SUBJECT: ISSUANCE OF AMENDMENT NO. 113 TO FACILITY OPERATING LICENSE
NO. DPR-51 - ARKANSAS NUCLEAR ONE, UNIT NO. 1 (TAC NO. 69056)

AMENDMENT TO FACILITY OPERATING LICENSE

Amendment No. 113
License No. DPR-51

SAFETY EVALUATION BY THE OFFICE OF NUCLEAR REACTOR REGULATION

Rod Position Setpoints for 4-Pump Operation
 From 0 to 27+10/-0 EFPD ANO-1 Cycle 9
 Figure 3.5.2-1A

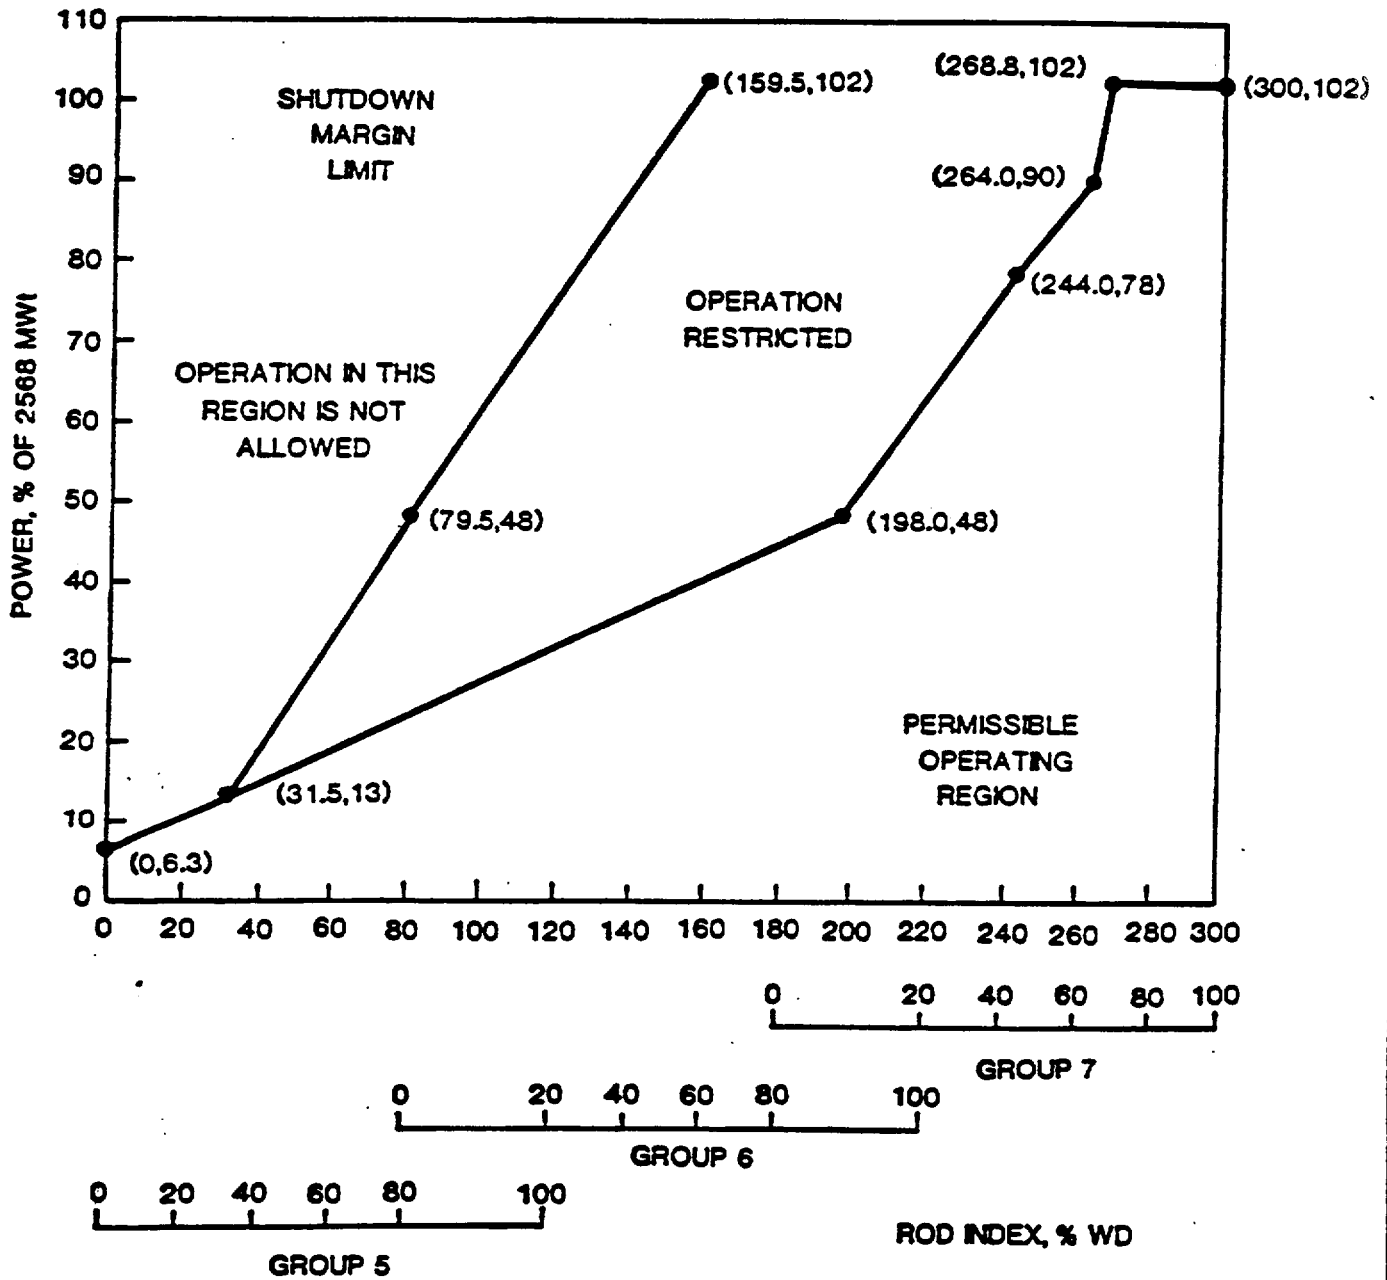
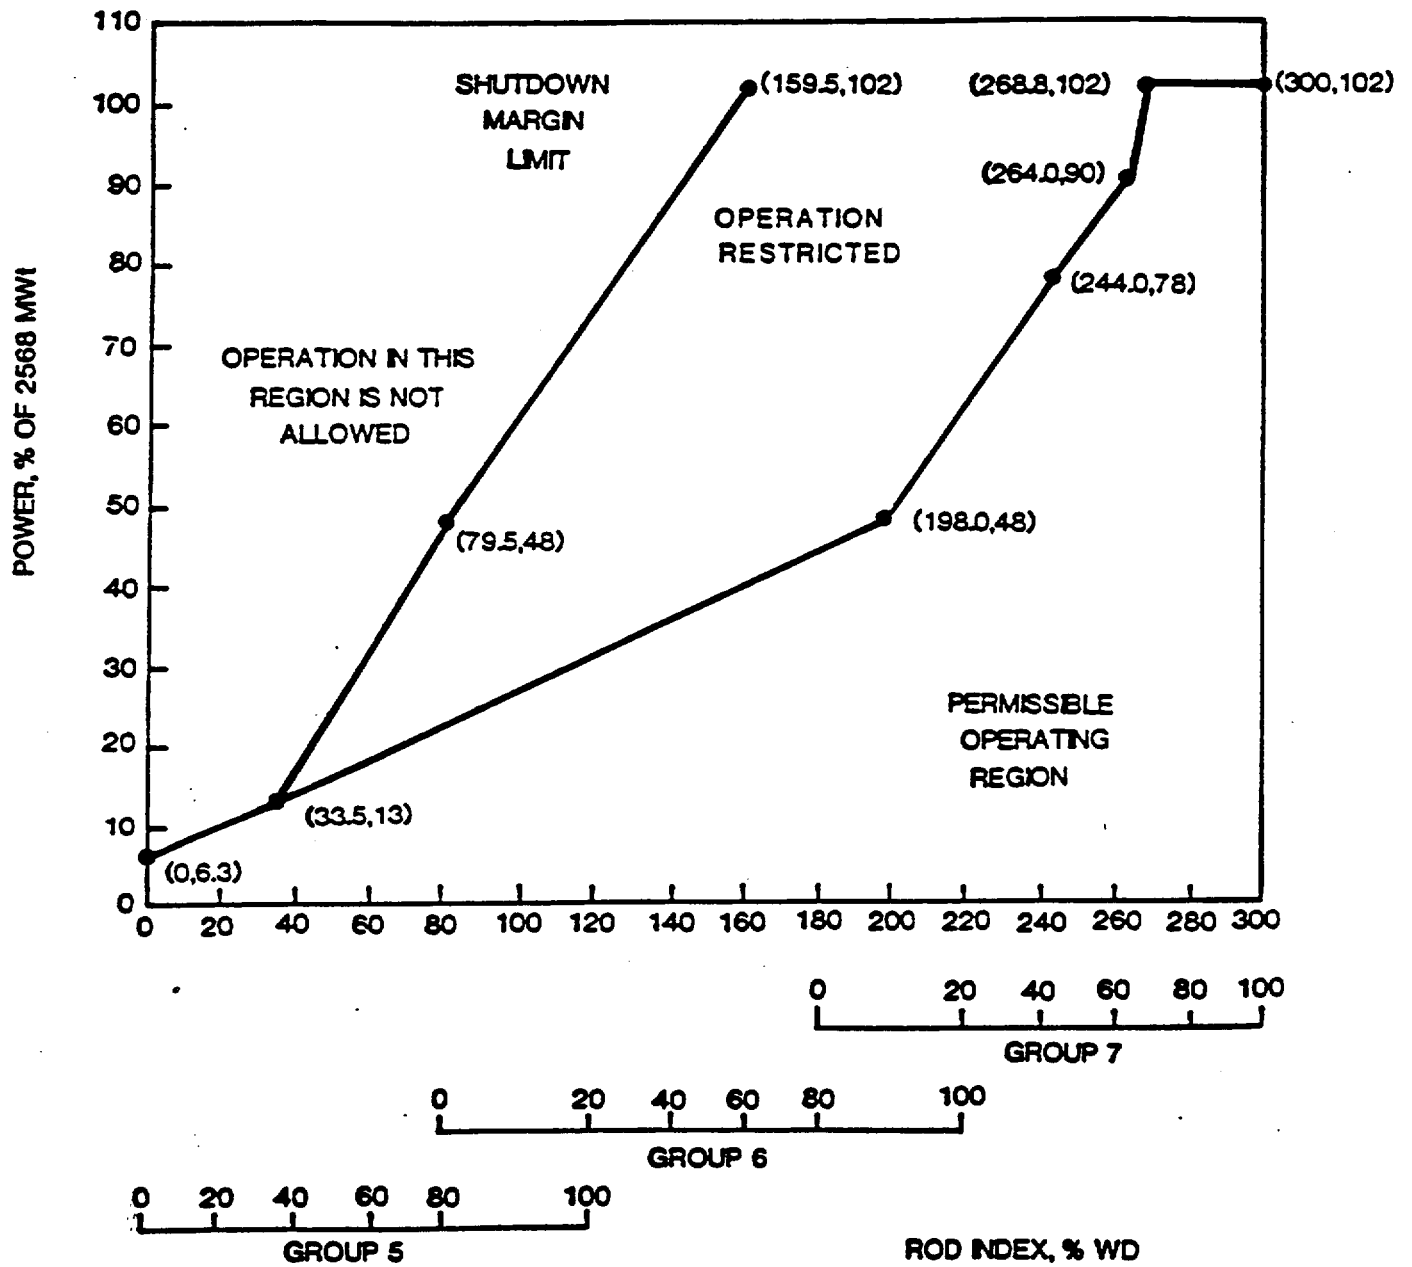
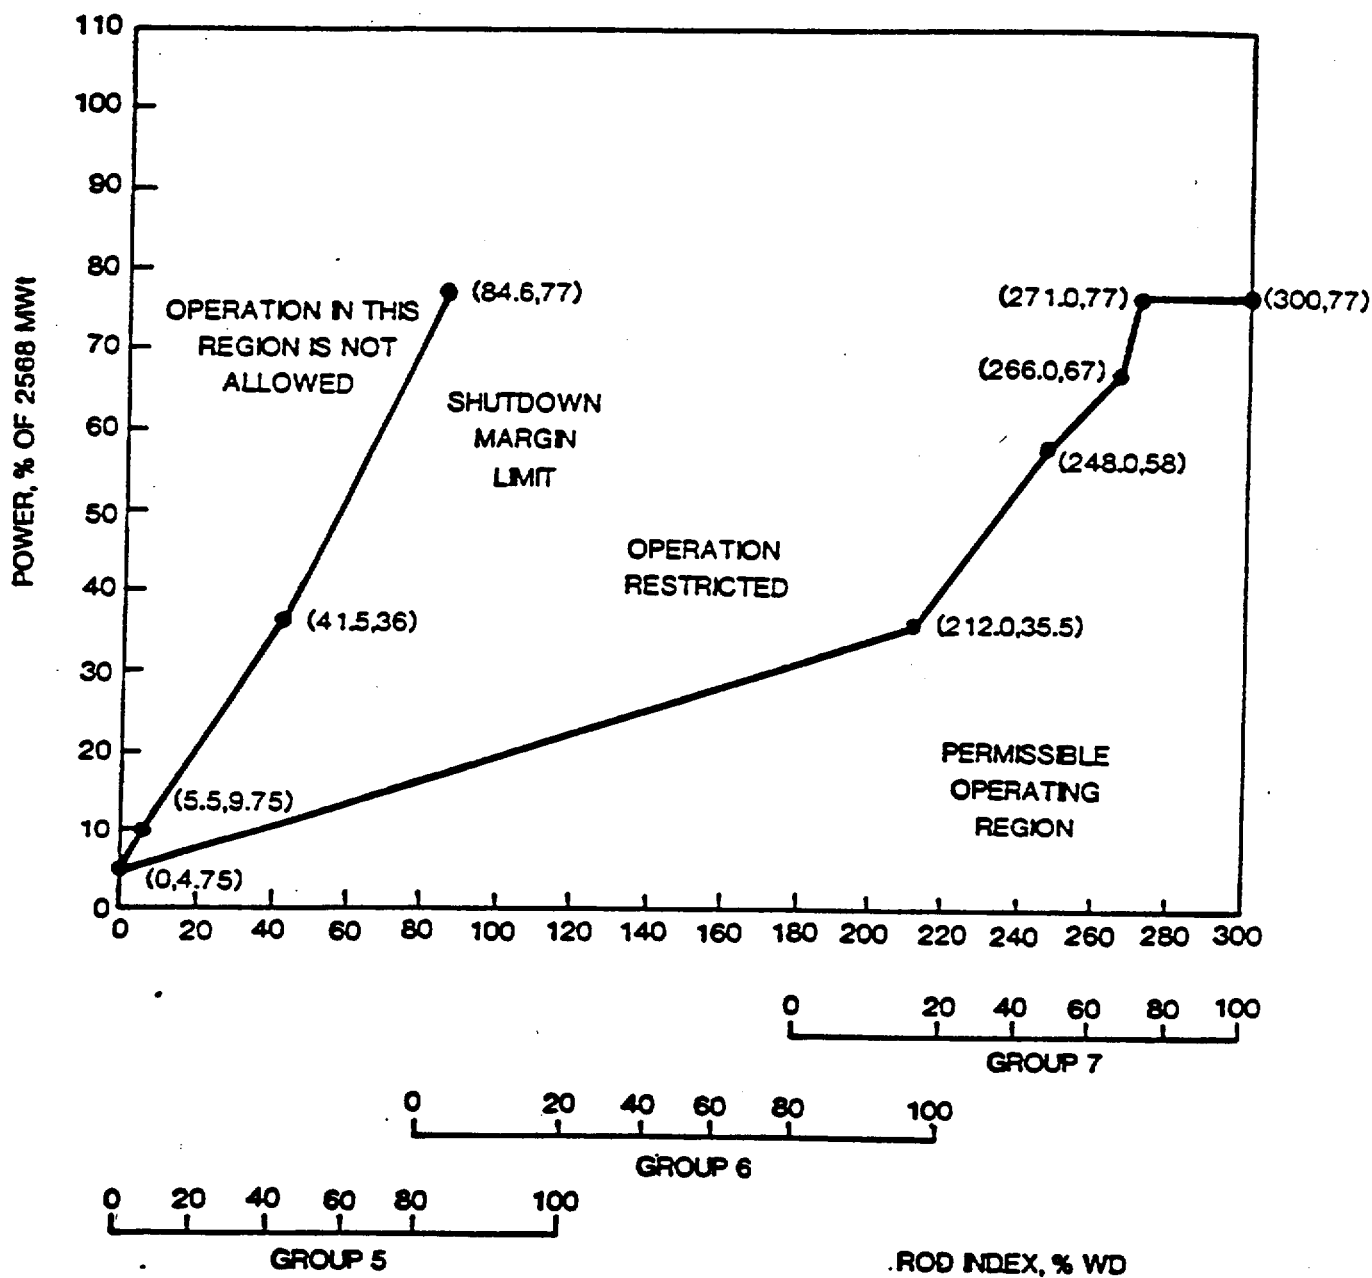
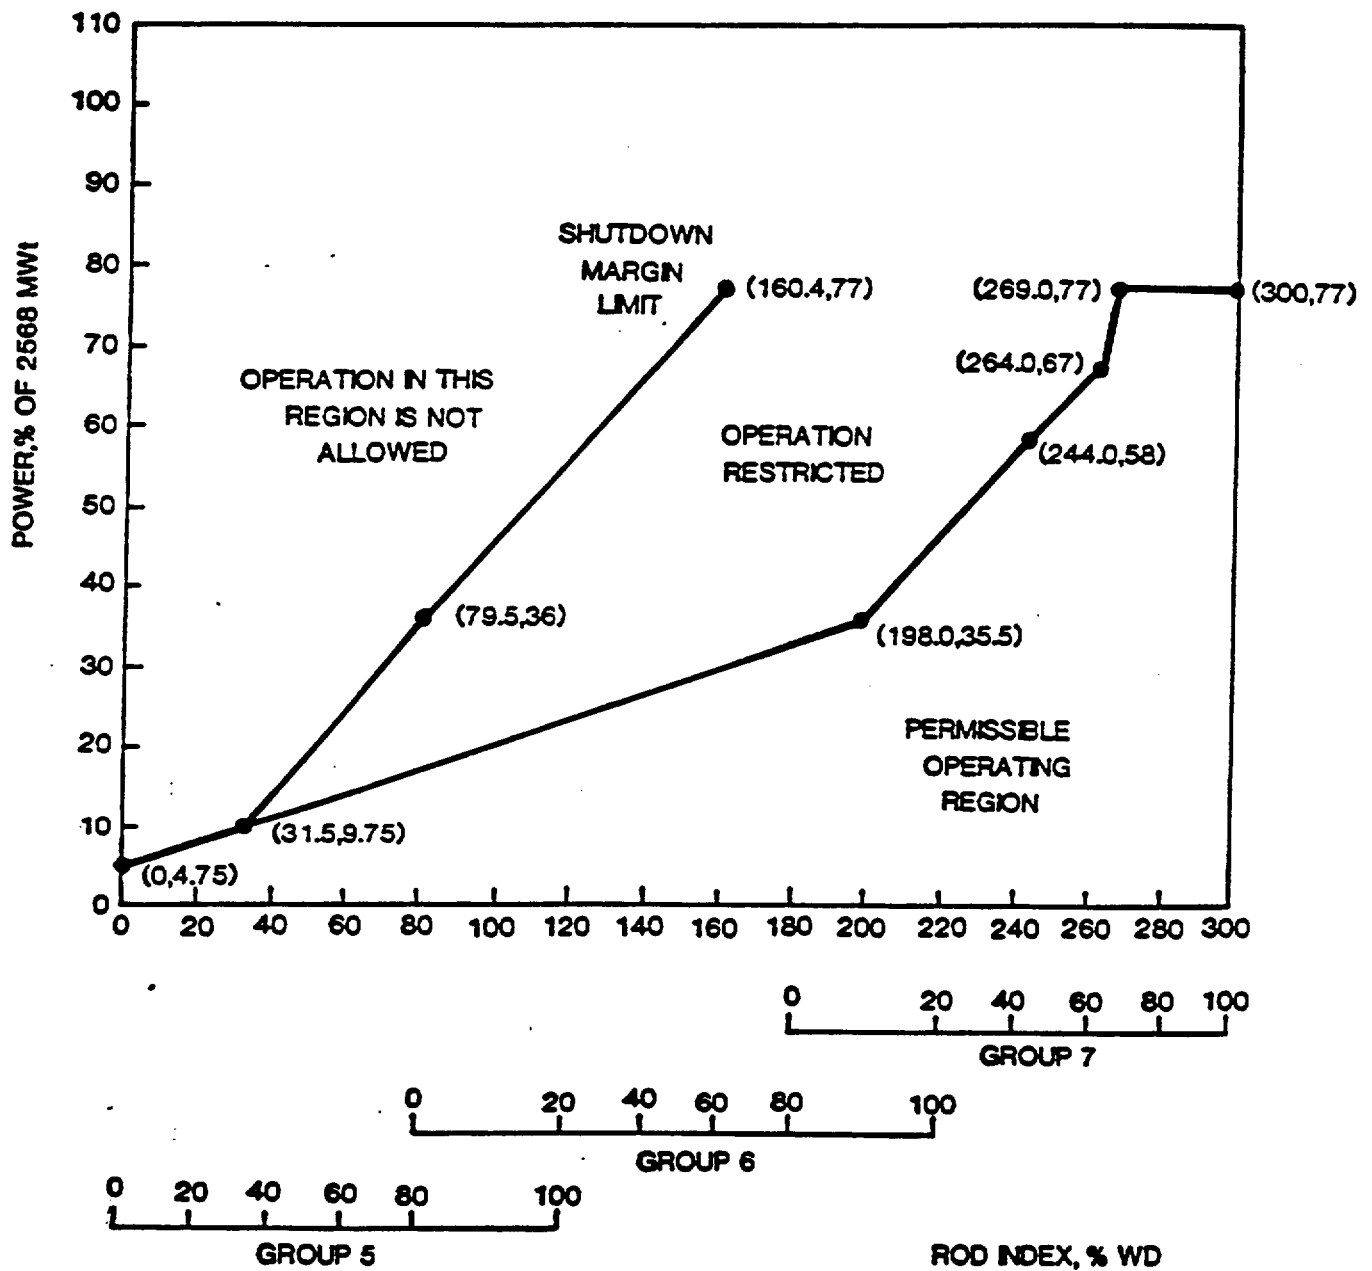
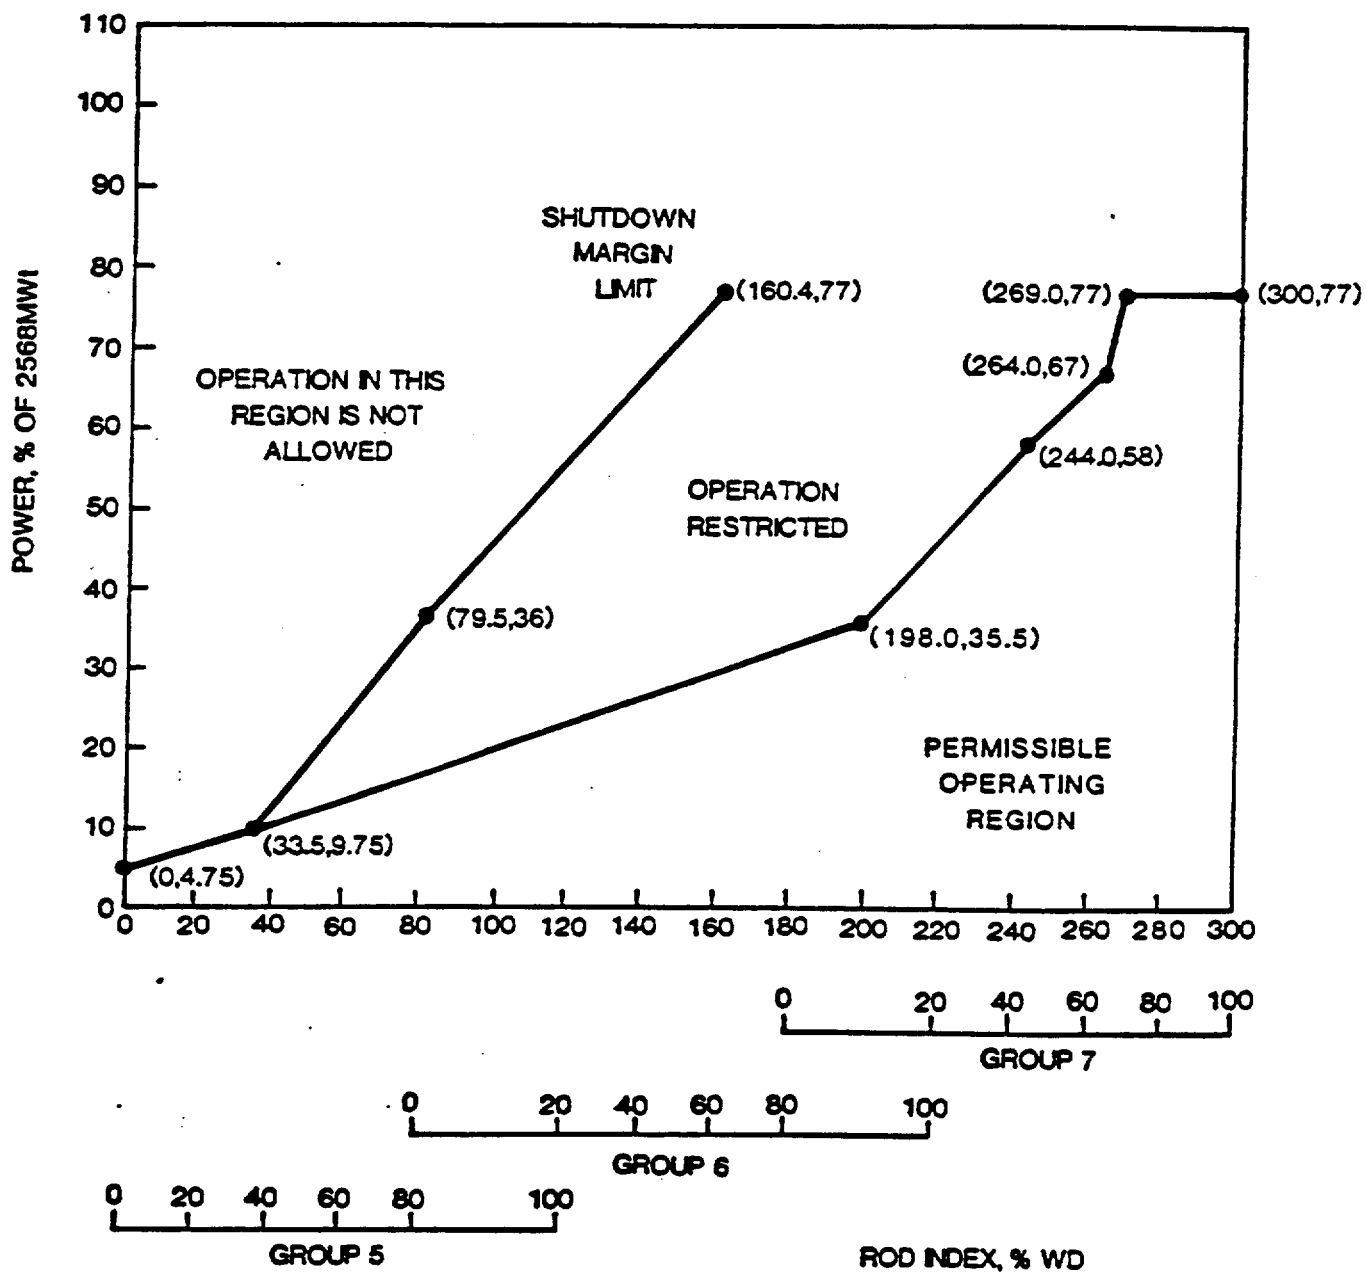
Section 3.5.2.4, 3.5.2.5.3, 3.5.2.5.4
Figures 3.5.2-1, 3.5.2-2 and 3.5.2-3, 3.5.2-4

These sections are modified to reflect new quadrant power tilt limits, changes to control rod insertion limits, operational limits on the gray axial power shaping rods (APSRs), and new operational power imbalance limit.
